ADDENDUM NO. 22

**REQUEST FOR PROPOSALS
(BID DOCUMENTS)**

**STUDENT SUCCESS CENTER
PROJECT NO. 950512**

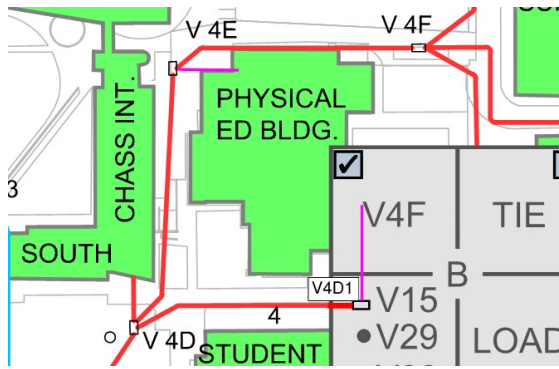
<p>Q121</p>	<p>The RFP as well as Addendum 15 Q/A 82 reference Simplex (JCI) as the only University accepted fire alarm system. Will the University allow EST (Edwards) to be used as an alternate for the fire alarm system on this project provided the system is code compliant and meets University requirements with the exception of the ability to network with the Campus?</p>
<p>A121</p>	<p>At this time the current campus infrastructure and operations can only support Simplex. The University will only accept fire alarm systems by Simplex for this project.</p>
<p>Q122</p>	<p>1. Vault V4D serves multiple existing buildings directly (Chass Inter. South, Athletics & Dance BLDG, & SSS). The feeder between V4D and V4C will be disconnected and re-routed during the project. Is there a pathway coming from the direction of V4E or another path in the green clouded area on the attached single line diagram that is adequately sized to provide power to V4D while the feeders from V4C are being relocated?</p> <p>2. Per Addendum 20, MC cable will not be allowed. It is industry standard to provide flexible MC cable connections to mechanical equipment and MC cable fixture whips from junction boxes to lighting fixtures. The home run circuits back to the electrical panels and circuits concealed in walls to receptacles and other devices will be in conduit. Please confirm MC cable will be allowed to mechanical equipment and to lighting fixtures.</p>

- The University Facilities Services has identified that there isn't an existing feeder that is adequately sized to serve the requirements of the buildings identified. The Design Builder will be required to build the new infrastructure prior to disconnecting / or cutting over the existing building feeds. Design Builder will have to adequately plan and phase construction activities to minimize impact to adjacent facilities.**
- The use of MC Cables is acceptable from the junction box to light fixtures only. The use of MC Cables is unacceptable to use for motors or vibrating mechanical equipment. Liquid-Tight flexible conduit with approved fittings to be used on all motors.**

PARTIAL ELECTRICAL SITE PLAN
CAMPUS 12KV EXPANSION - 1
UNIVERSITY OF CALIFORNIA - RIVERSIDE

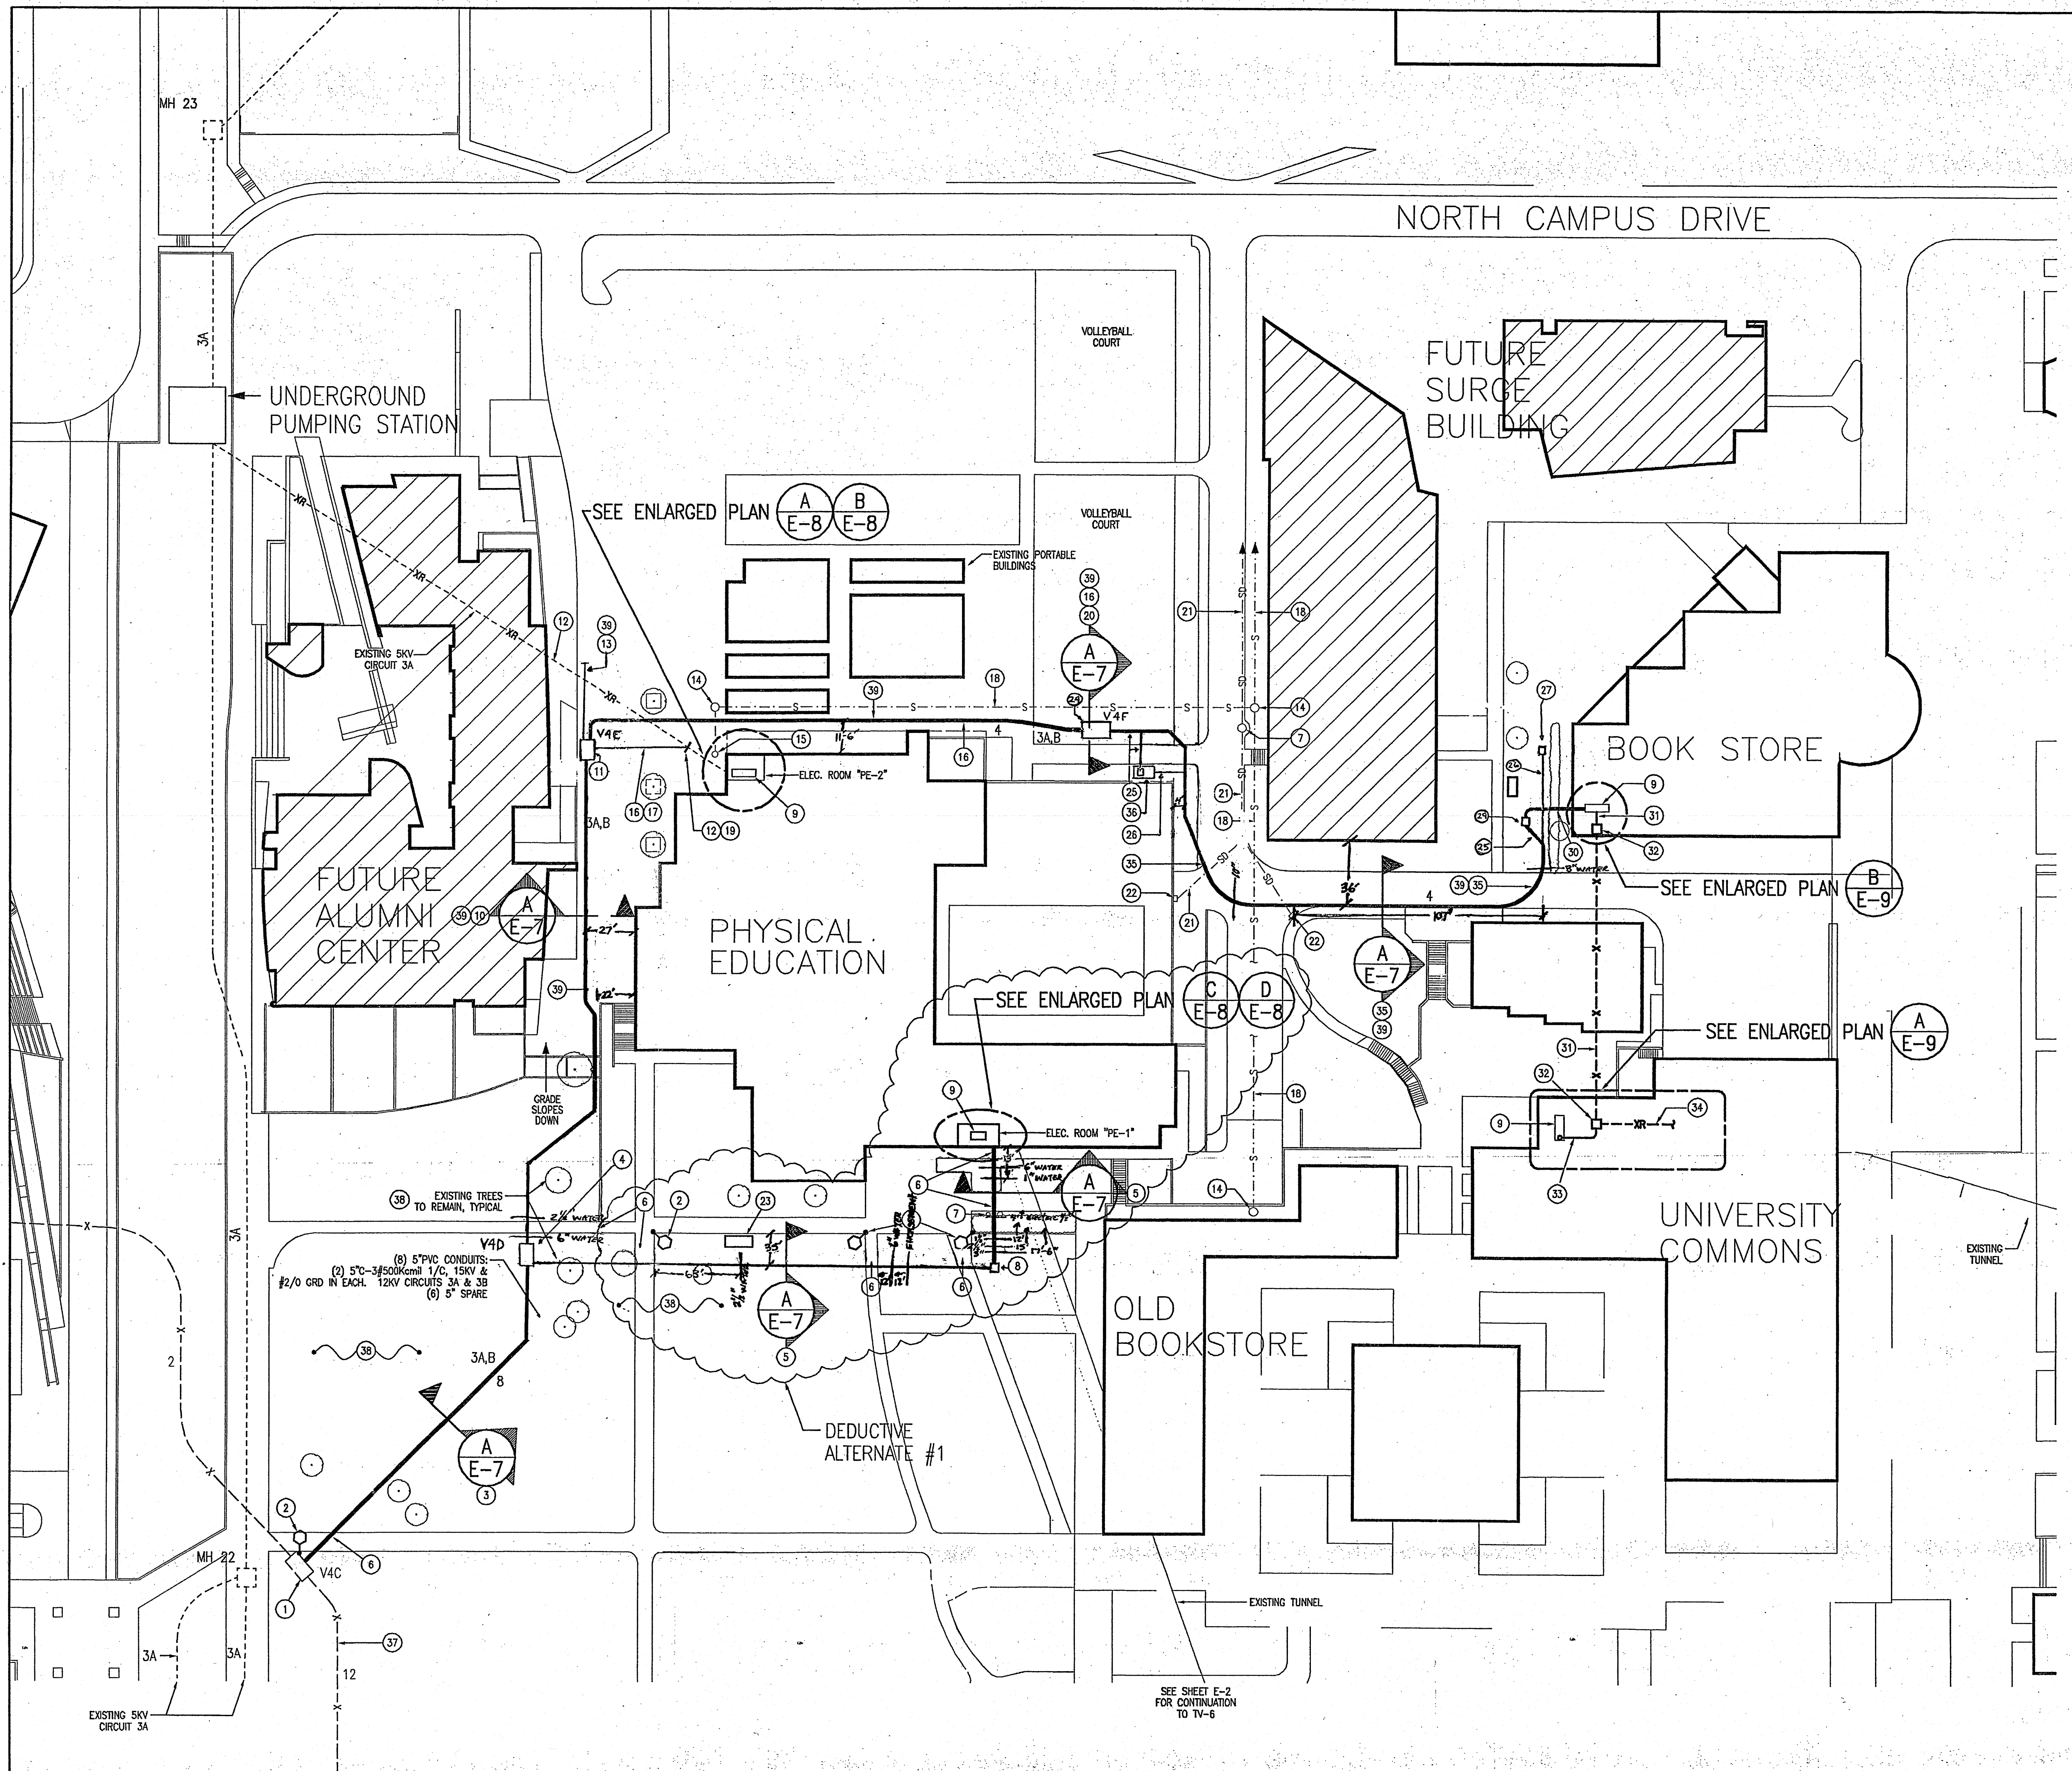
Reference Addendum 08, File 35-A-6079_E2-12kv Layout and University Furnished Information, As-Builts, Student Academic Support Services Electrical Drawing Sheet E6.01 and specifically Detail A on Sheet E6.01.

Both documents indicate a second service at the Athletic building. Our review of University-furnished-information shows the location of the original service to the Athletic Building, PE-1. If the above provided information is correct, there is a second service connected to the 12kv circuits in vault V4D leading us to believe there may have been a second substation installed in the Athletic building (perhaps in the Military Science Wing expansion; reference University Supplied

<p>Information – As-Built - B. Physical Education Building\Original Bldg – 18_83340_6278_Proposed Transformer Vault.</p> <ol style="list-style-type: none"> 1. Please provide the location of Athletic Building electrical service PE-2. 2. Please provide record drawing(s) showing conduit pathway, quantity and size of conduits (including any spares if applicable), and size of 12kv conductors connecting electrical service PE-2 to Vault V4D. 3. If service PE-2 is NOT connected to Vault V4D, please confirm location of PE-2's connection to campus 12kV service.
<p>A123</p>	<p>There are two services at the Athletics Building.</p> <ol style="list-style-type: none"> 1. There are two feeds to the Athletic and Dance Building. There is a feed from vault 4E and a second feed between Student Services and the Athletics and Dance building to Vault 4D-1. Please find diagram below illustrating above:  <ol style="list-style-type: none"> 2. Please refer to the Electrical drawings E-4 an E-7 issued with Addendum No. 22
